Re: Chevron Service Station # 9-2029

Address: 890 West MacArthur Blvd., Oakland, California

Re: **Conduit Study**
Chevron Service Station 9-2029
890 W. MacArthur Blvd.
Oakland, California
Fuel Leak Case #RO0002438

Subject: Fuel Leak Case No. RO0002438, Chevron #9-2029, 890 West MacArthur Blvd.,
Oakland, CA 94608

FIGURE
1

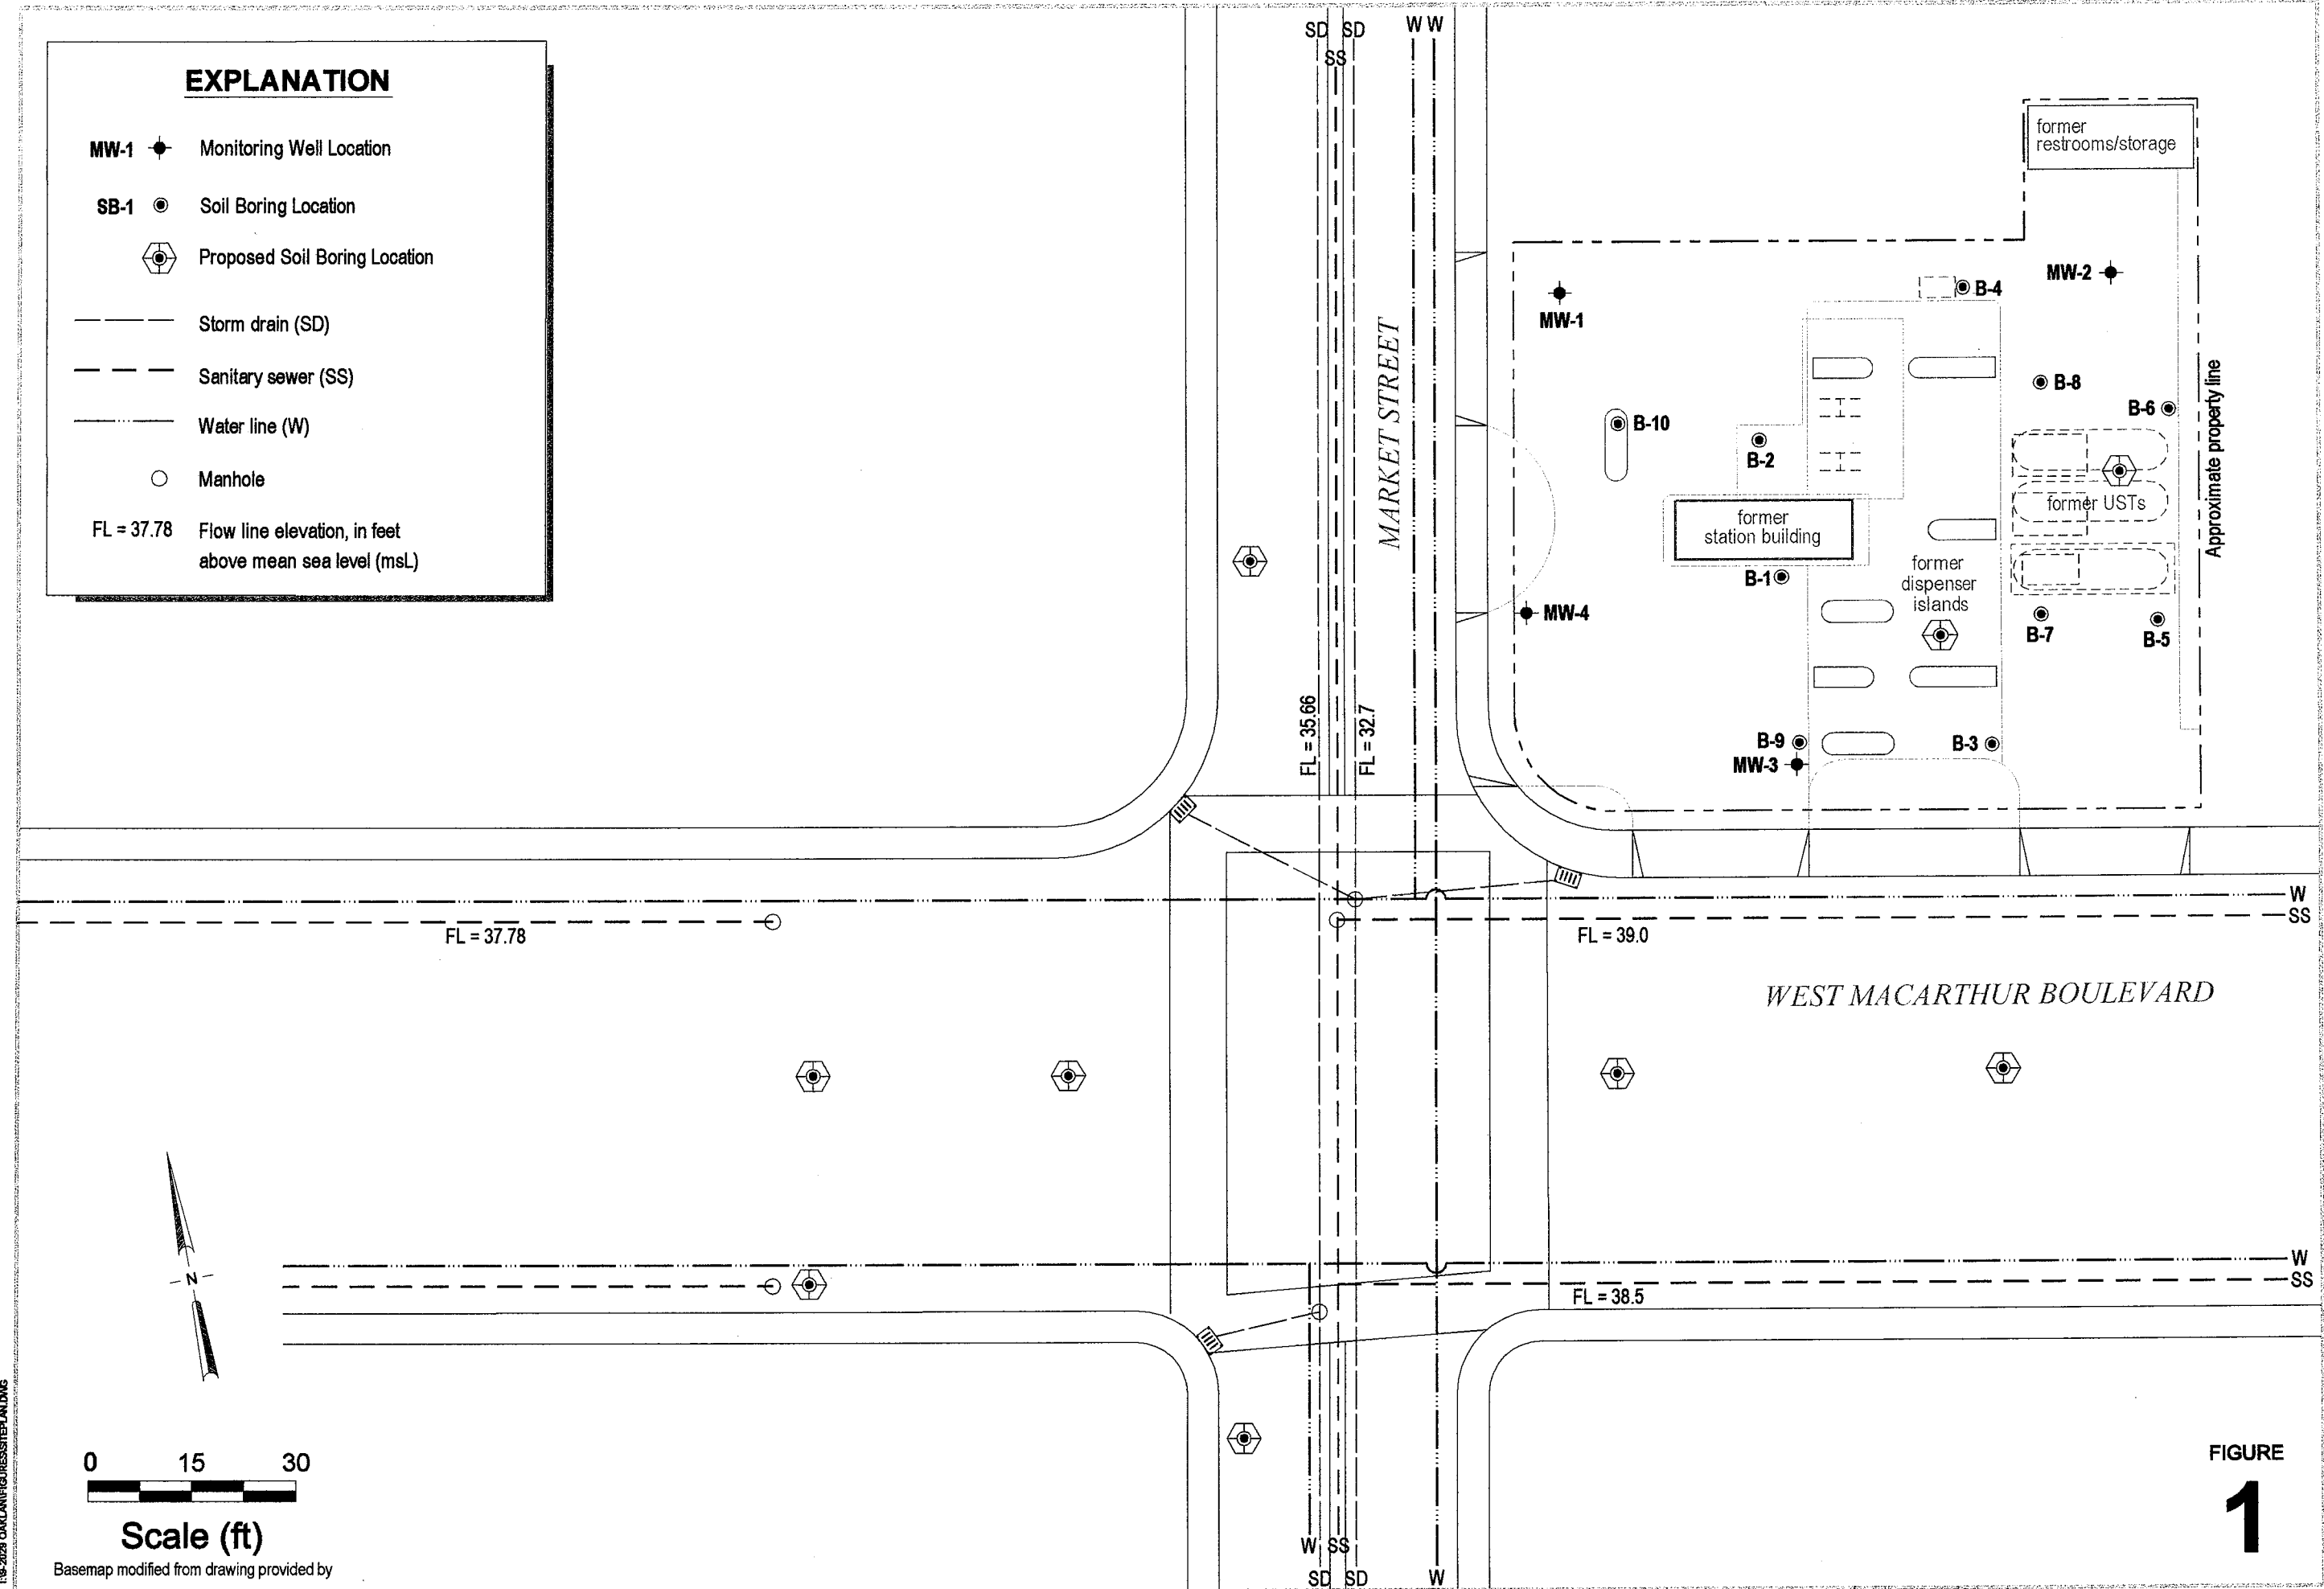
1. **Conduit Study-** A conduit study was not proposed in your work plan as requested in our 8/26/05 letter. Therefore, prior to performing the proposed work, we request you perform a utilities/conduit study to insure that the proposed boring locations are not affected by existing preferential pathways. Please submit your conduit study as requested below and confirm your conclusion regarding the utilities and conduits with our office prior to performing the proposed work.

Cambria identified several utilities in the site vicinity by reviewing East Bay Municipal Utility District (EBMUD) and the City of Oakland utility maps. As shown on Figure 1, water lines run parallel with West MacArthur Boulevard on the north and south sides, along the east side of Market Street, and down the center of Market Street south of West MacArthur Boulevard. Sanitary sewer and storm drain lines run along the center of Market Street, and along the north and south sides of West MacArthur Boulevard. Telephone, communication and electrical lines are above ground in the site area.

Historical depth to groundwater measurements at the site range from approximately 8 feet below grade (fbg) to 11 fbg. The depth to flow-line (dtfl) in the storm and sewer lines are approximately 7 fbg to 15 fbg. Using these measurements, the base of the trench backfill material for these lines is estimated at approximately 8 fbg to 16 fbg.

The depth to water in wells MW-3 and MW-4, near the intersection of MacArthur Boulevard and Market Street where the subsurface utilities are located, has ranged from approximately 8 to 11 fbg. The greatest estimated depth of utility trench backfill materials associated with these utilities is likely 16 fbg. While groundwater appears to intercept the trench backfill, construction techniques prior to 1975 when these buried utility lines were installed, native material was used as backfill. The native material at this depth likely consisted of clays and silts with low permeability; therefore, it is unlikely that any trench backfill in the site vicinity provides a significant pathway for preferential groundwater flow and based on the locations of identified, buried utility lines, no change in location of proposed soil borings is necessary.
